**TOWN OF MOUNTAIN VILLAGE
REGULAR DESIGN REVIEW BOARD MEETING AGENDA
THURSDAY MARCH 30, 2023 10:00 AM
MOUNTAIN VILLAGE TOWN HALL
455 MOUNTAIN VILLAGE BLVD, MOUNTAIN VILLAGE, COLORADO
TO BE HELD HYBRID THROUGH ZOOM:**

**DESIGN REVIEW BOARD MINUTES
TOWN OF MOUNTAIN VILLAGE
REGULAR DESIGN REVIEW BOARD MEETING
MARCH 2, 2023**

A007

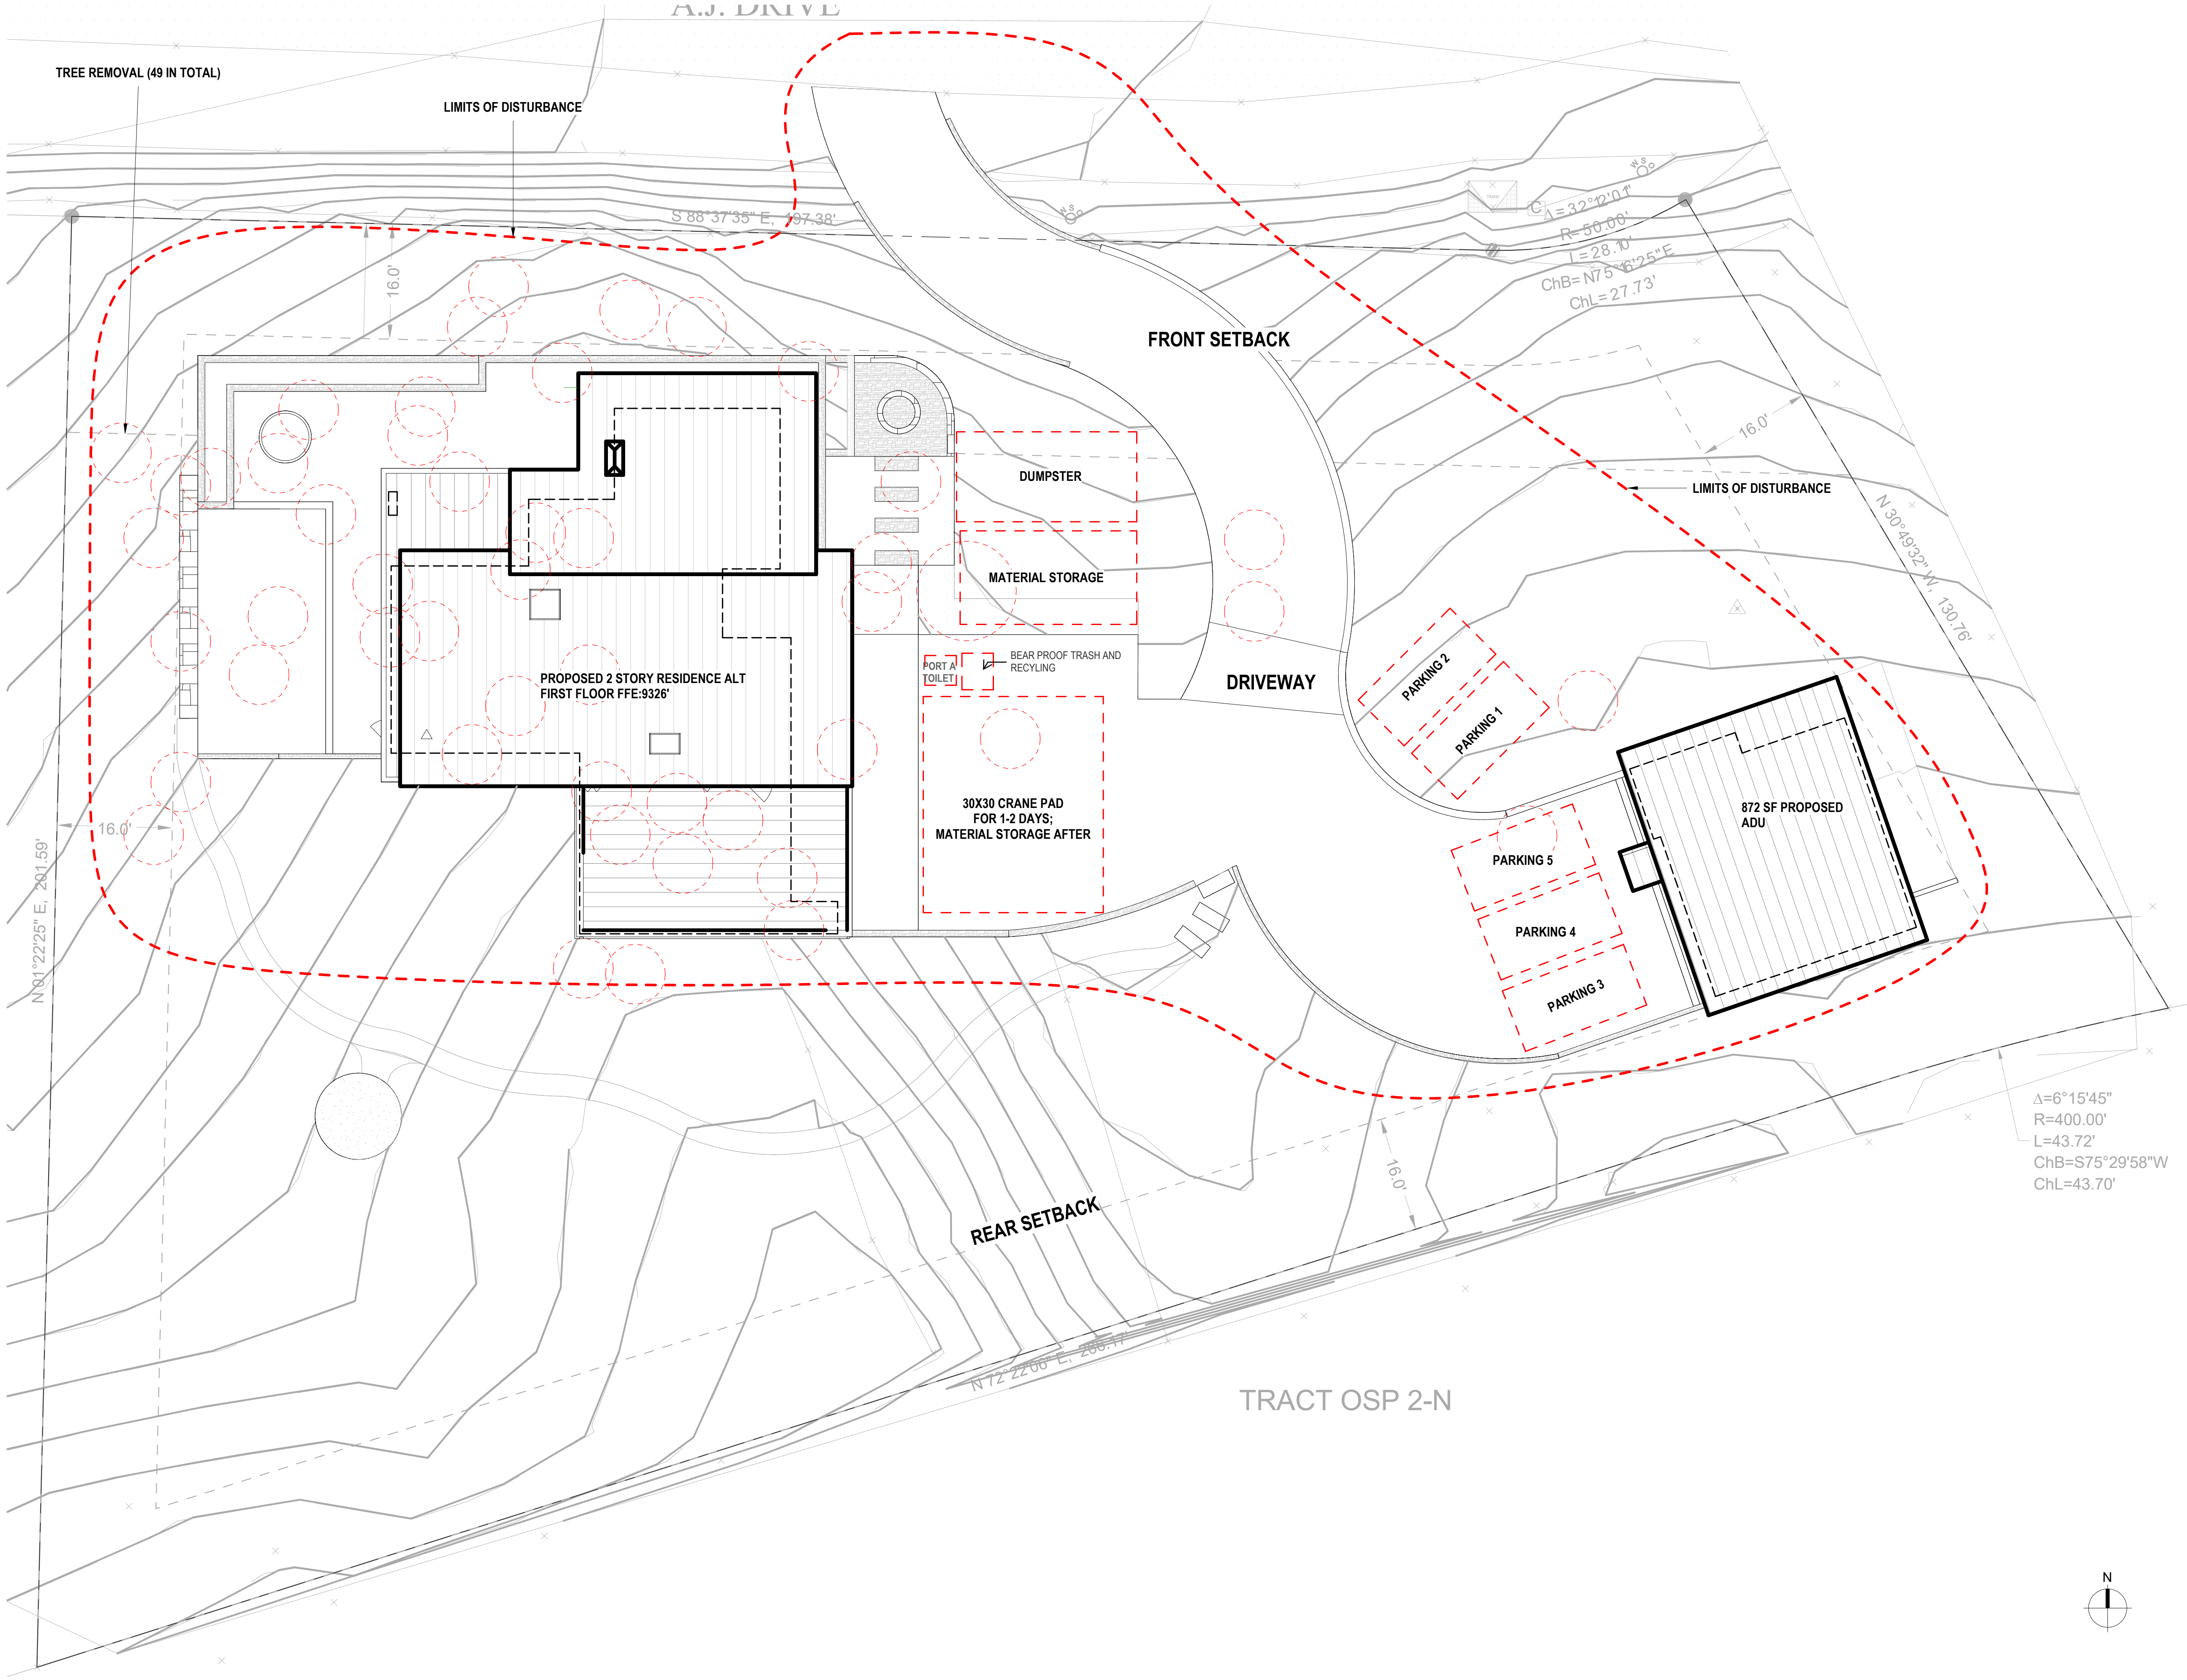
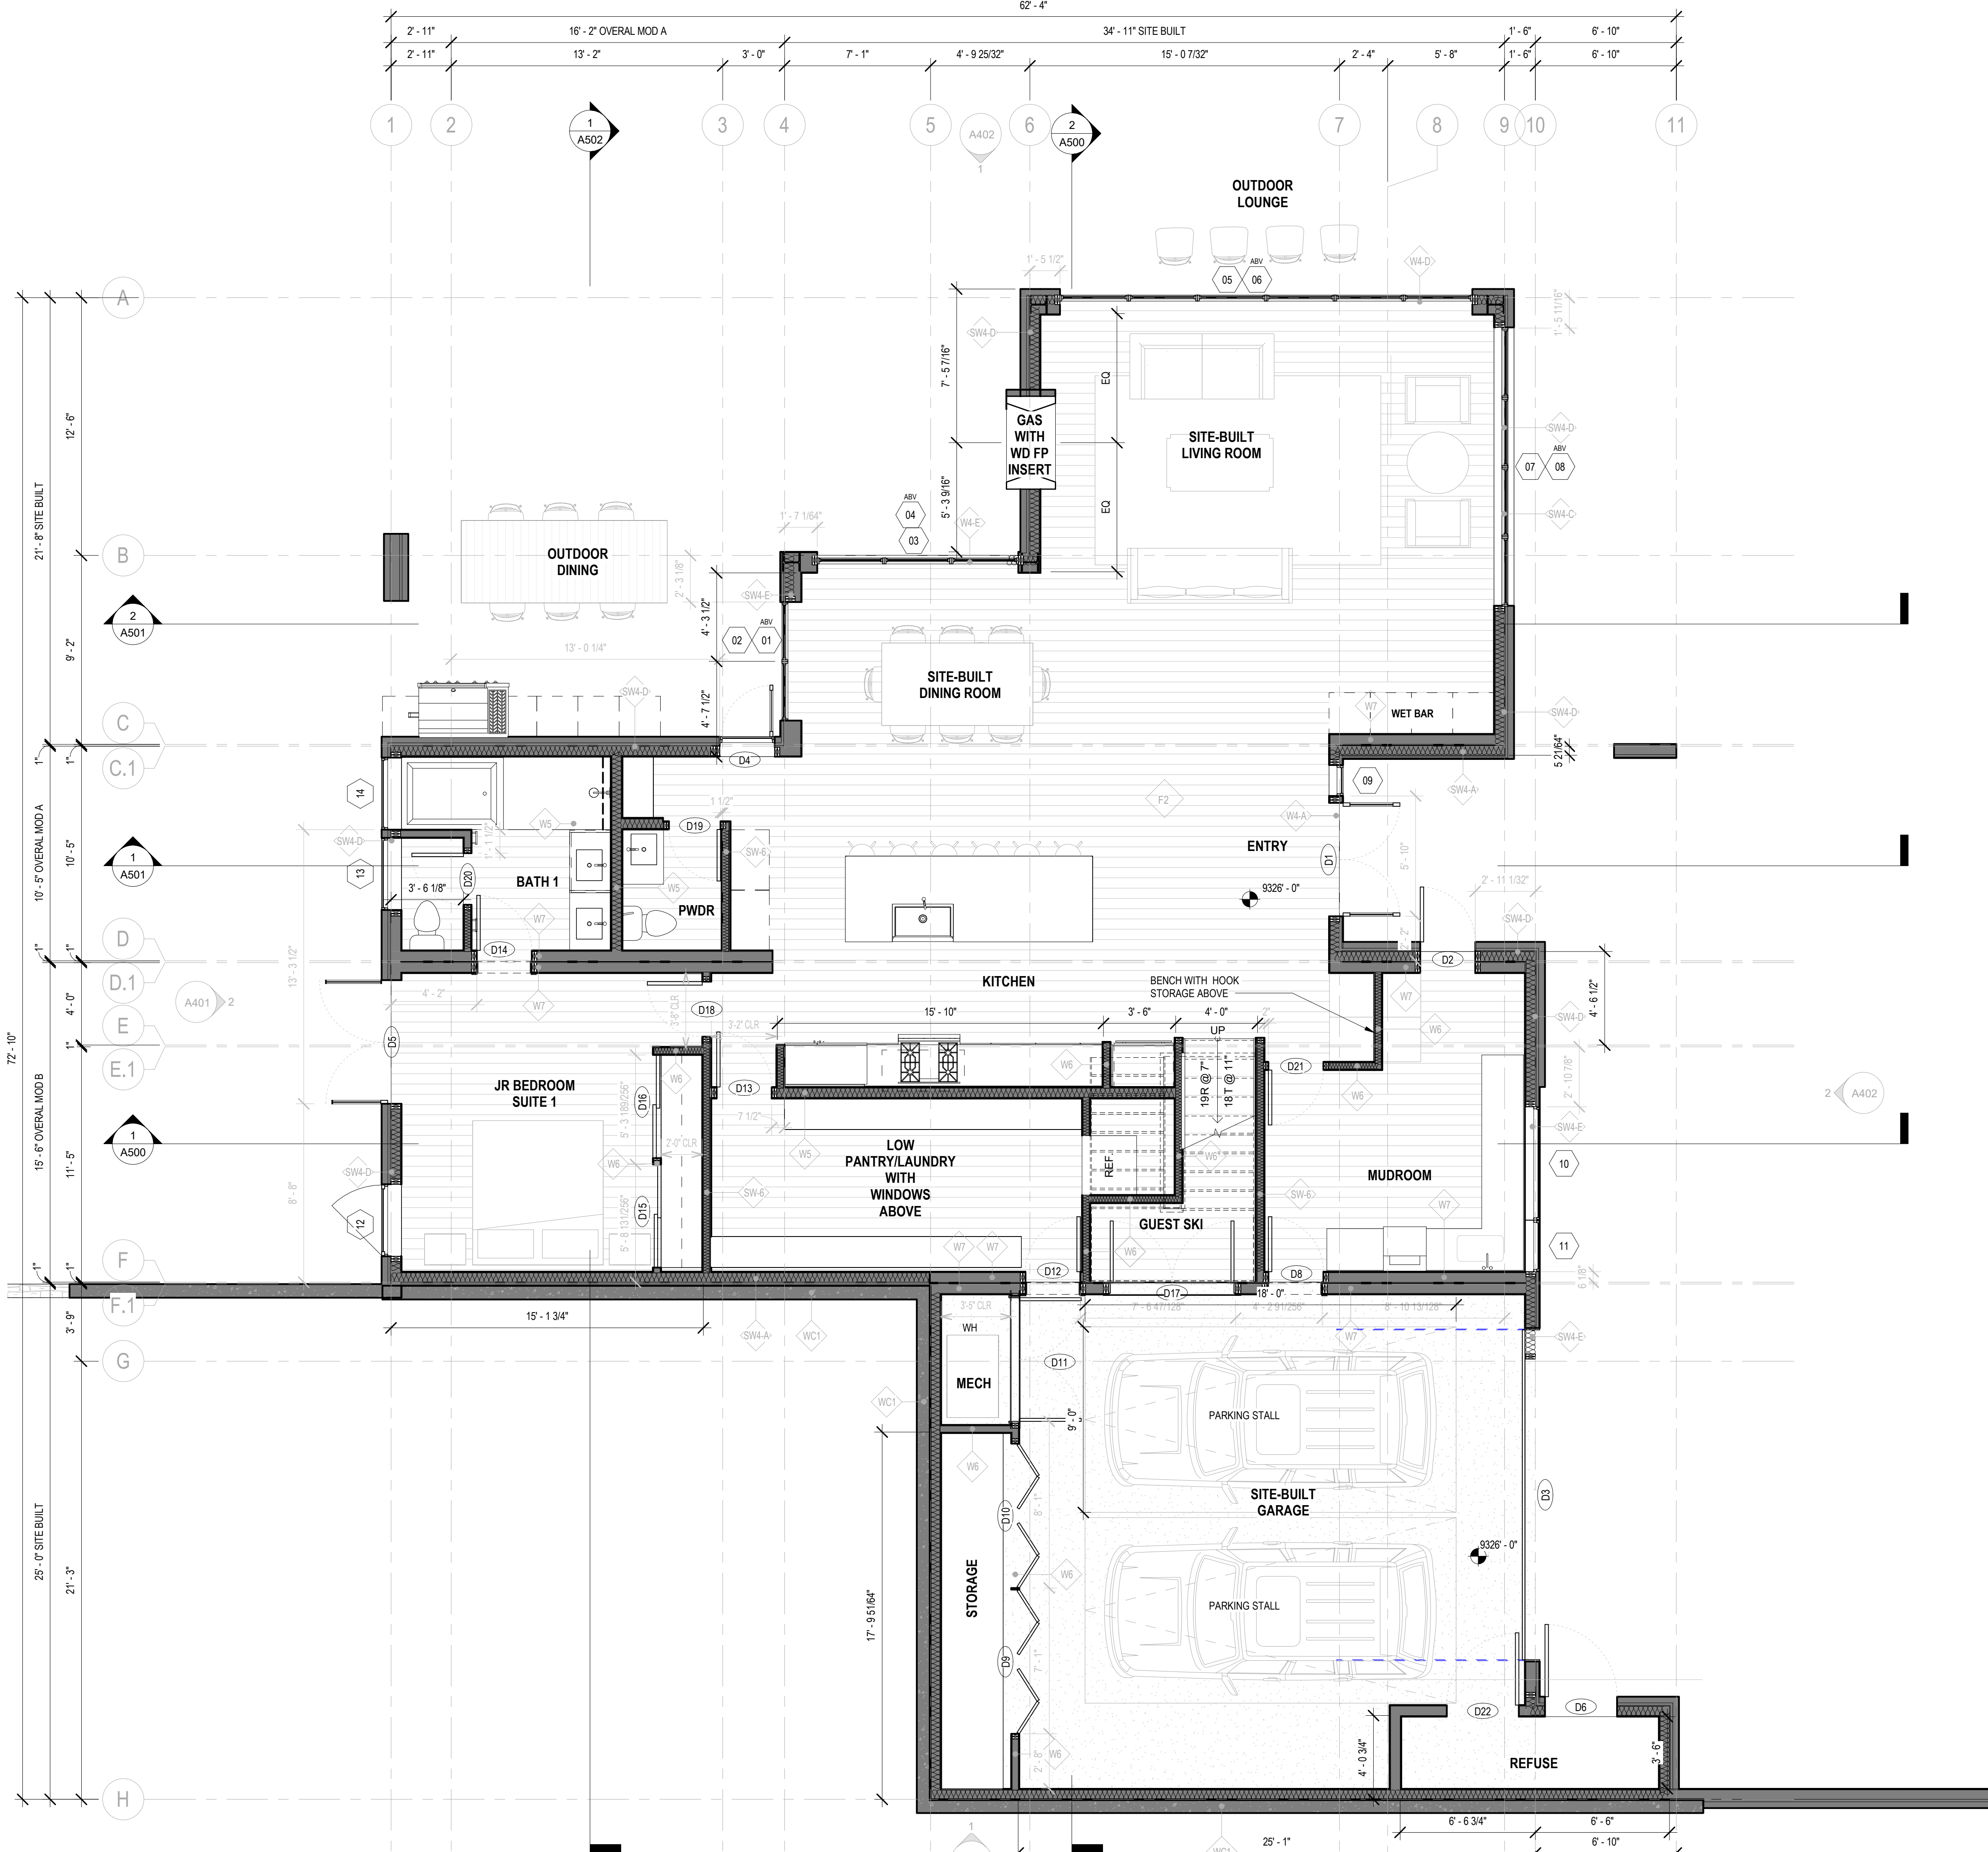
Staff: The applicant provided an updated construction mitigation plan on Sheet A007. The updated plan shows the required dumpster, material storage, bear proof trash and recycling, and a port-a-toilet. The updated plan also indicates a staging plan to mitigate the slope of the site and material storage, which is shown on Sheets C5.1 and C5.2.

The construction mitigation plan has also been updated to show appropriate silt protection through an Erosion Control Plan on Sheets C5.1 and C5.2. The plan also does not show tree protection measures for any trees that will remain on site. The plan should be revised to include these requirements prior to final review.
